Shared-Use Nonmotorized (SUN) Trail Network

A Northern alignment is proposed for a 4.7 mile long SUNTRAIL section. fpn 429823-1

This is a pic of an 1100' section of the largely 8' non-compliant North side path just constructed just East of Rt 31.

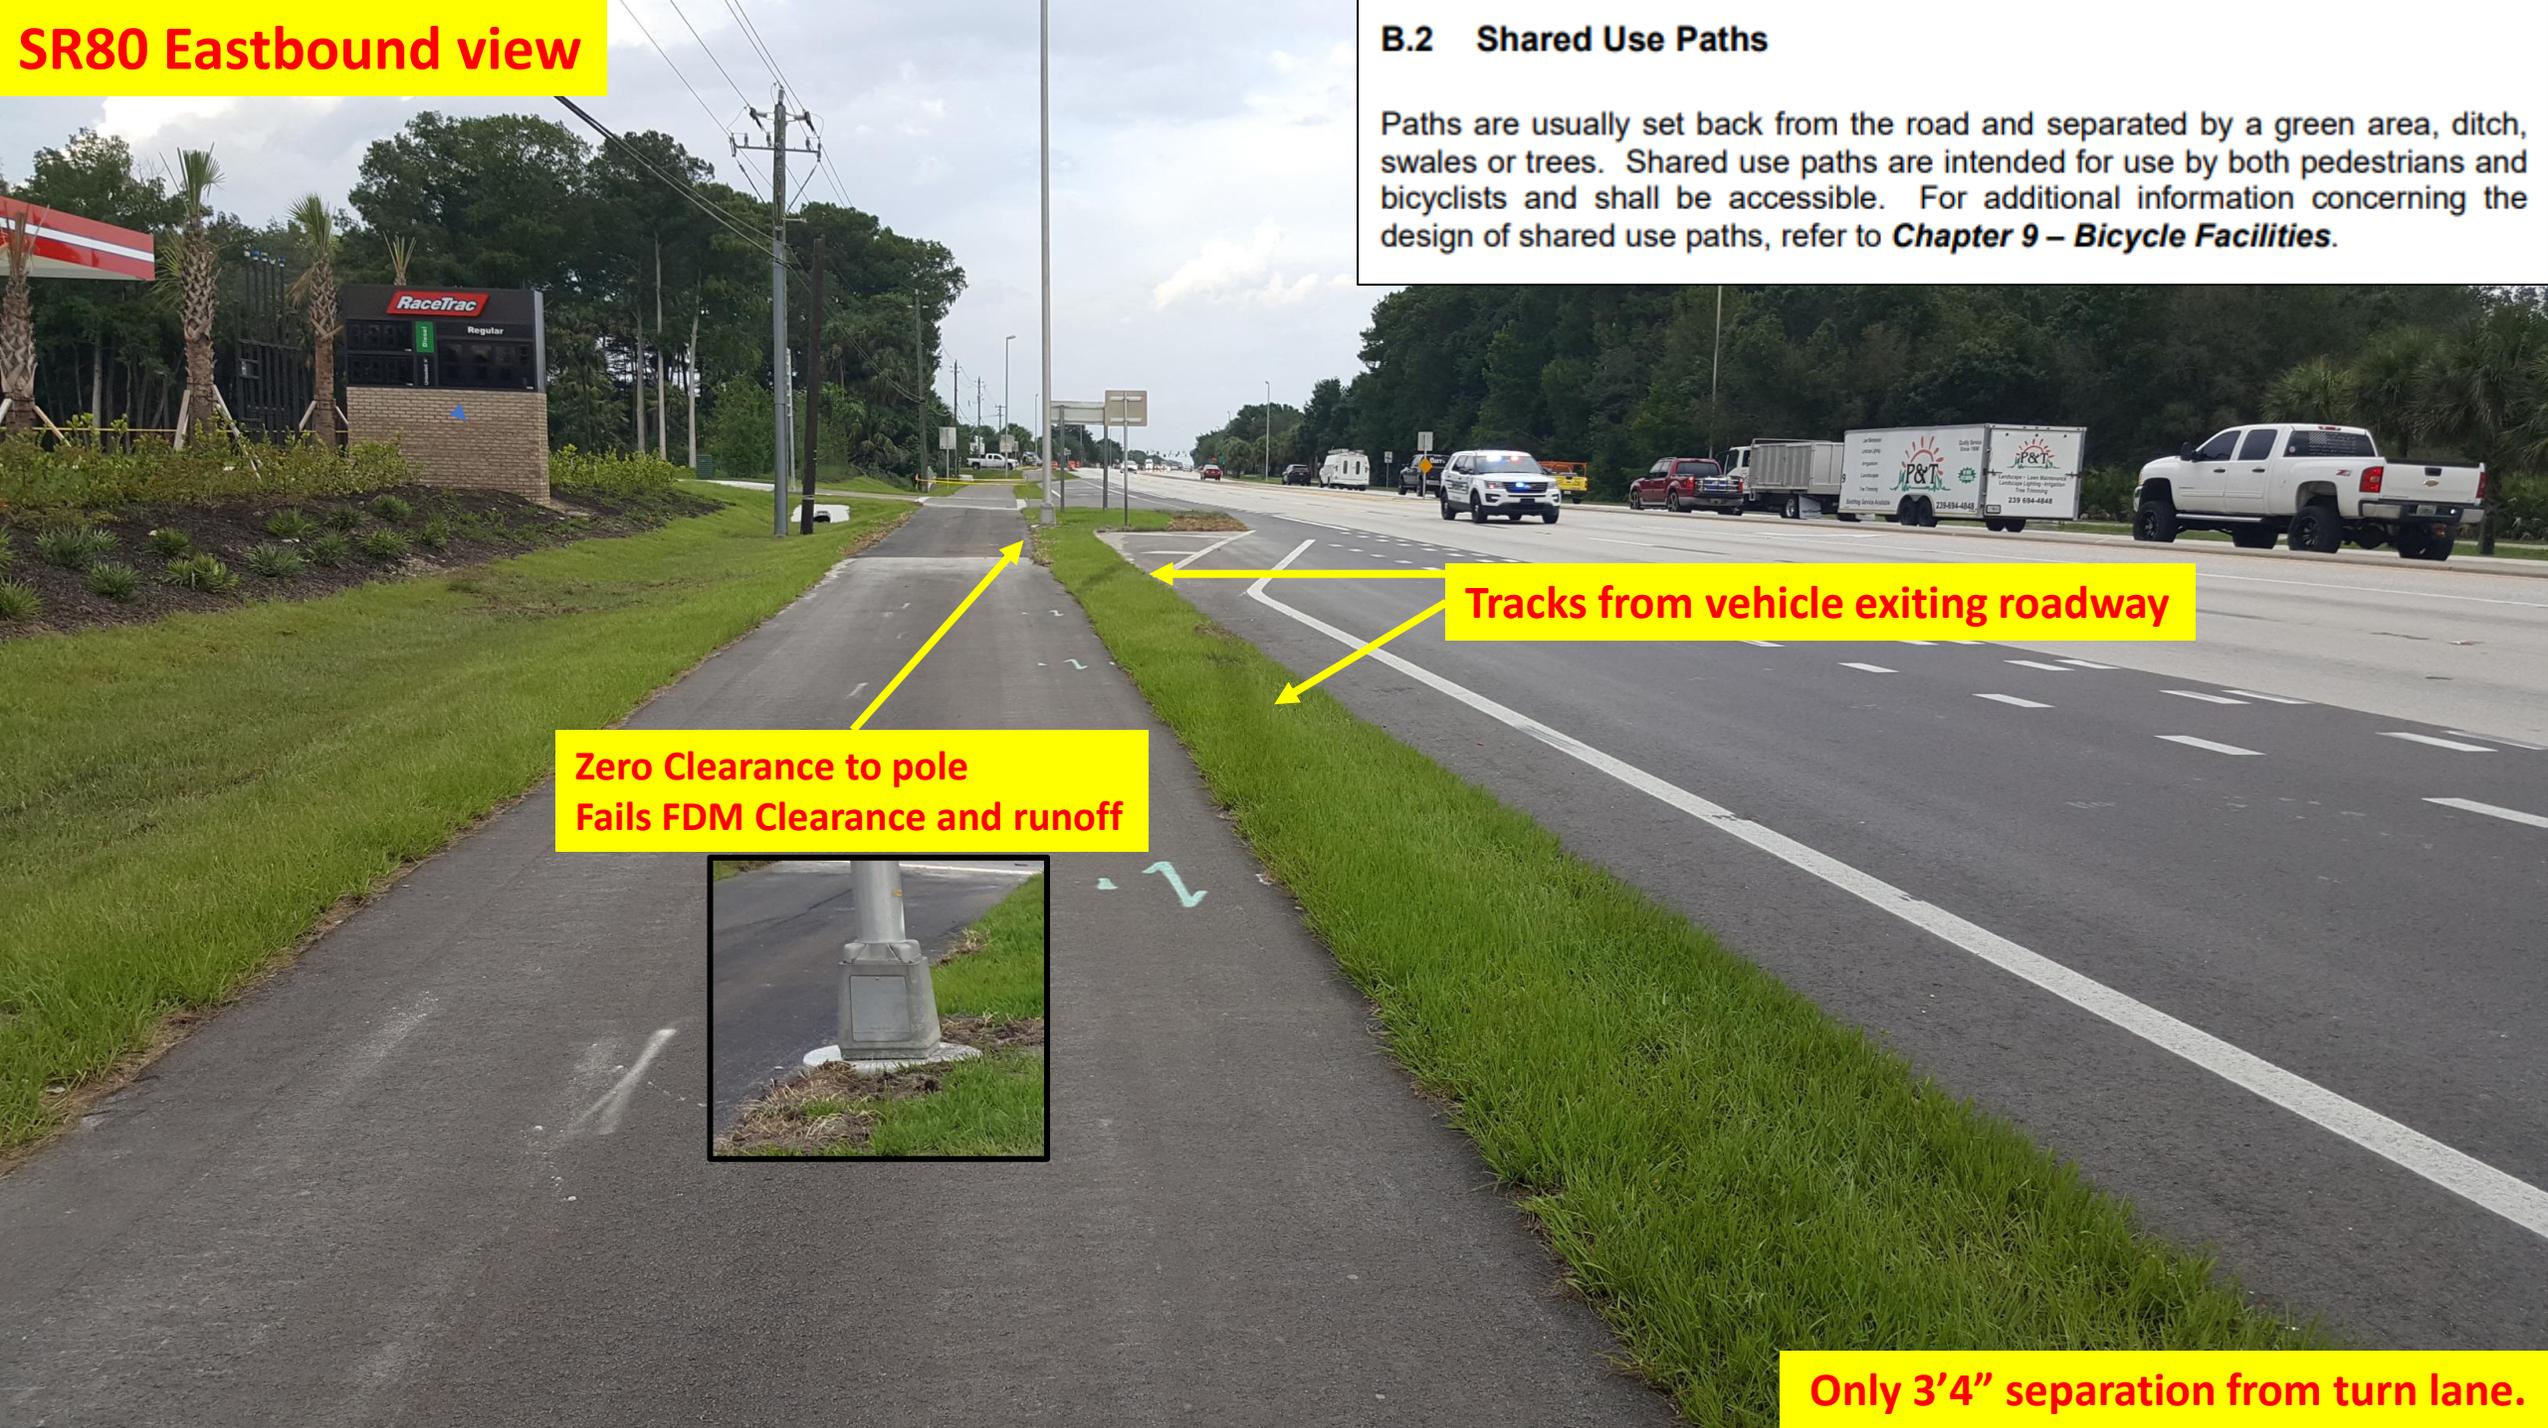
Proposed 8' Section Fails FDM Width, Separation, and Clearances.

Roadway Separation Less than 5 Feet Wide.

Storm Drain in Path Fails and also should be turned 90 degrees

The Pathway is the lowest point, which is why in light rains stormwater flows from all 3 lanes of the roadway and the grassy runoff area down the middle of the Path to the storm drain.

(Sections below are all only 8' wide and abut SR80)

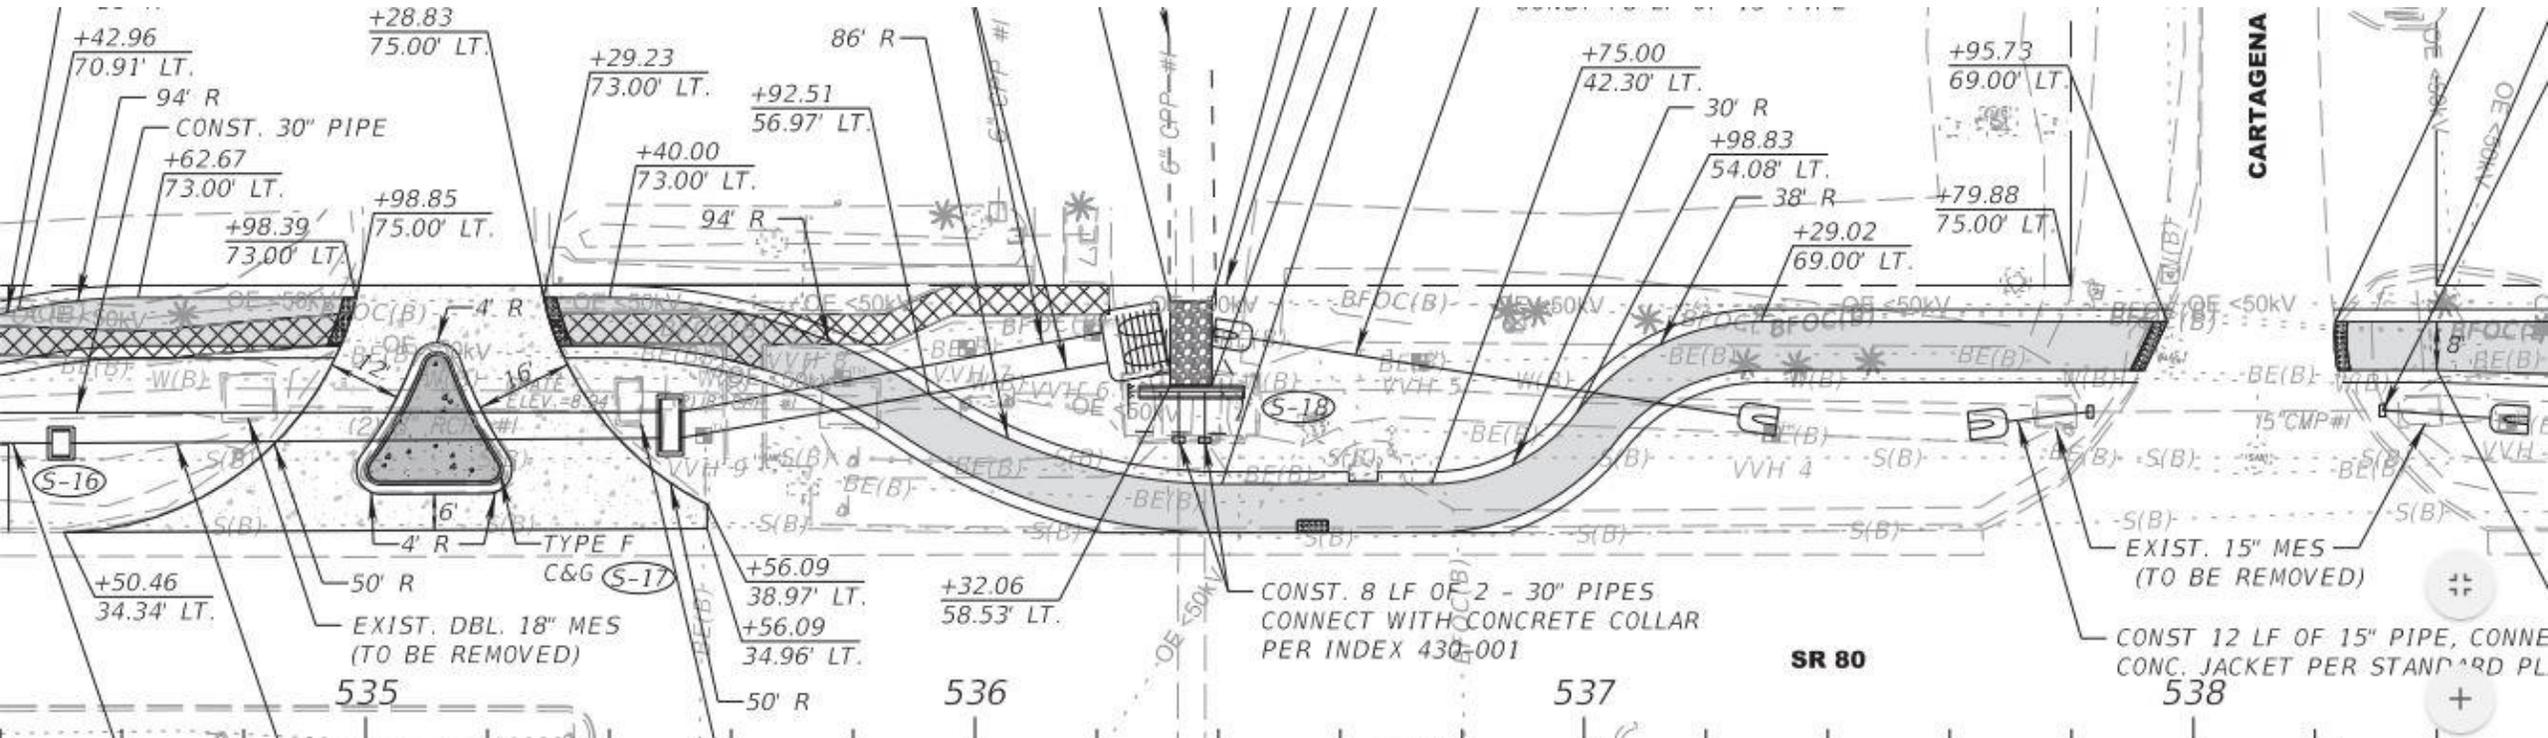
Has the FDOT Chief Planner in Tallahassee approved the deviations from FDOT Design Manual? We need to ask her. **FDOT Chief Planner Ms. Huiwei Shen 850 414 4911** The mitigation handbook directs exploring alternatives before approving exceptions.

The section below looks like the Path runoff area overlaps highway lanes like an onramp and offramp. Possibly, to get around the creek. Not really sure.

A 6' to 8' wide Concrete Sidewalk should be constructed along the North Side of SR 80 and a 10' to 14' wide Asphalt Multi Use Trail or Shared Use Path constructed along the South side.
